**REVISION 001 TO AN
INVITATION TO TENDER**

Title - Sujet : Greenwich Beach Complex Rehabilitation, Prince Edward Island National Park	
Solicitation No. - N° de l'invitation : 5P201-19-0103/B	Date : November 29, 2019
Amendment No. - N° de modification : 001	
Client Reference No. - N° de référence du client : 191146	
GETS Reference No. N° de reference de SEAG : PW-19-00897010

Amendment 001

This amendment is raised to answer questions from bidders.

drawing
**DOOR JAMB
& DOOR SILL
DETAILS**

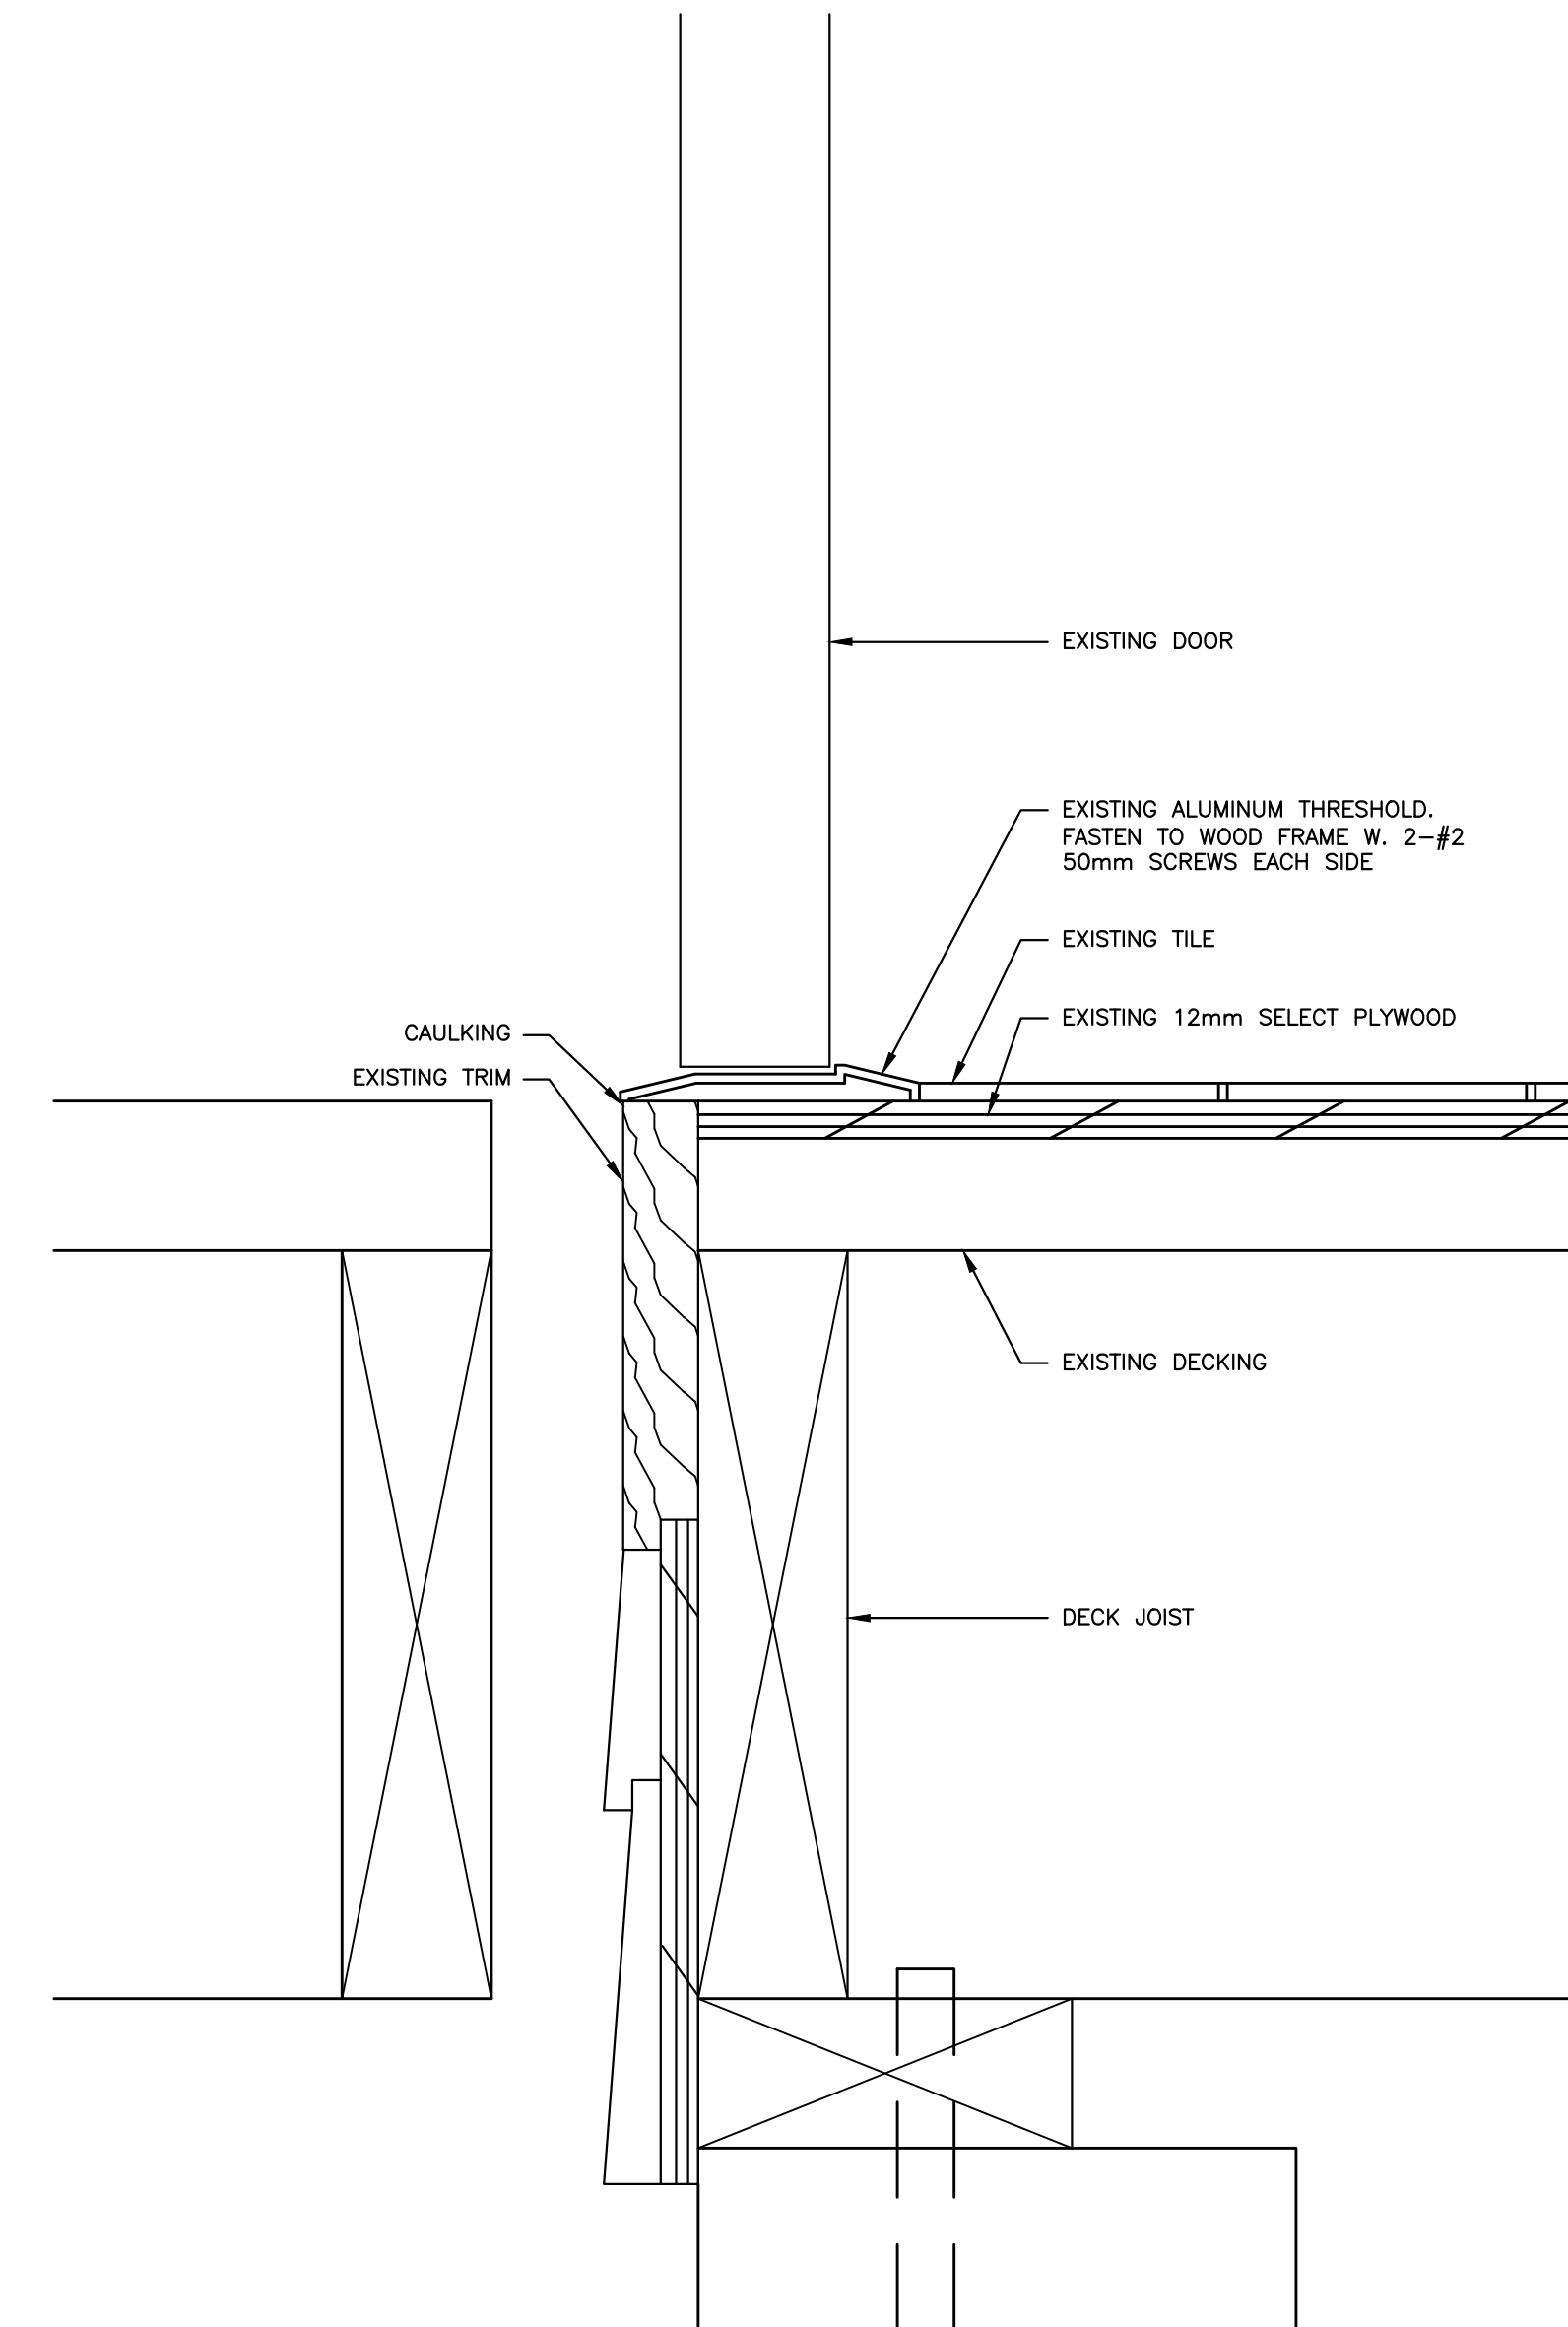
Q1. Please provide details for doors 104.1 and 105.1 as none is provided.

A1. Refer to attached drawing.
